**QUESTIONS AND ANSWERS REGARDING
MSCAA PROJECT 18-1415-01
AIRFIELD SIGNAGE REPLACEMENT – CONSTRUCTION
MAY 27, 2021**

**All questions are listed as submitted. Company names are withheld.
This Addendum No. 1 includes questions received through May 25, 2021.**

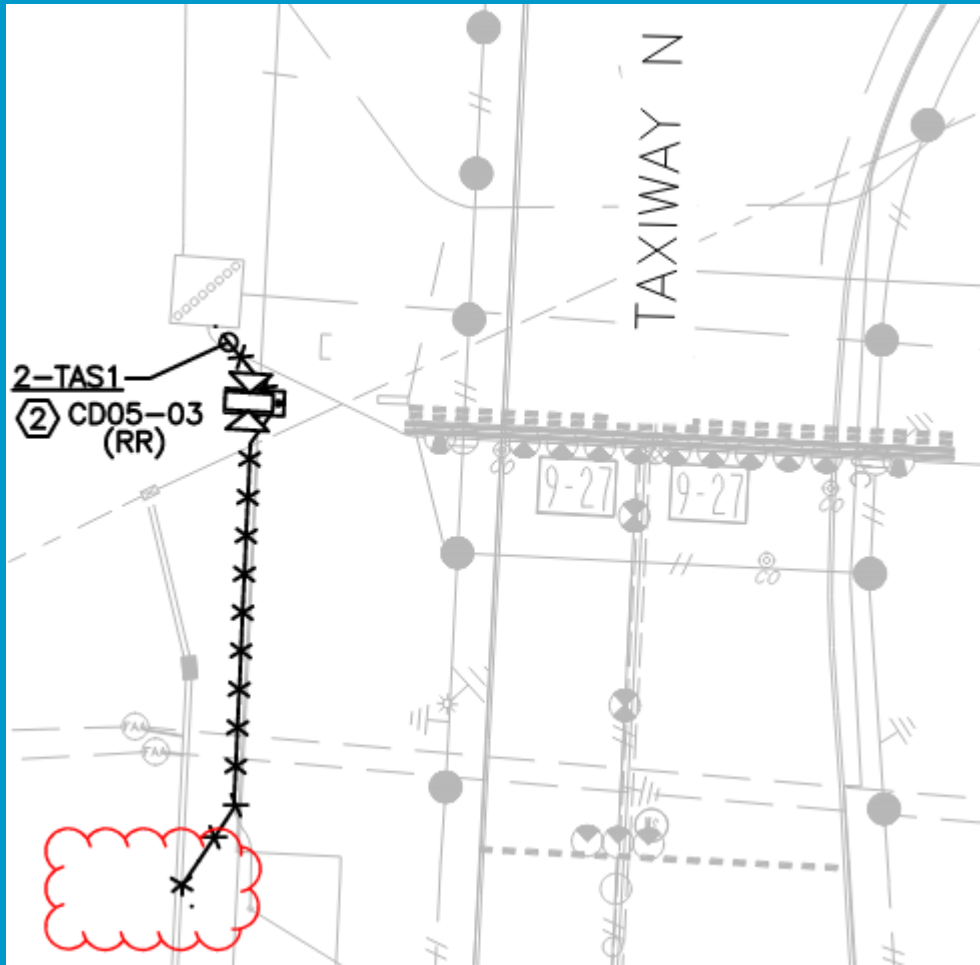
Please clarify if there is a manhole or base can at the end of the demolition of this conduit.

Response: There is a junction base can at the end of this conduit.
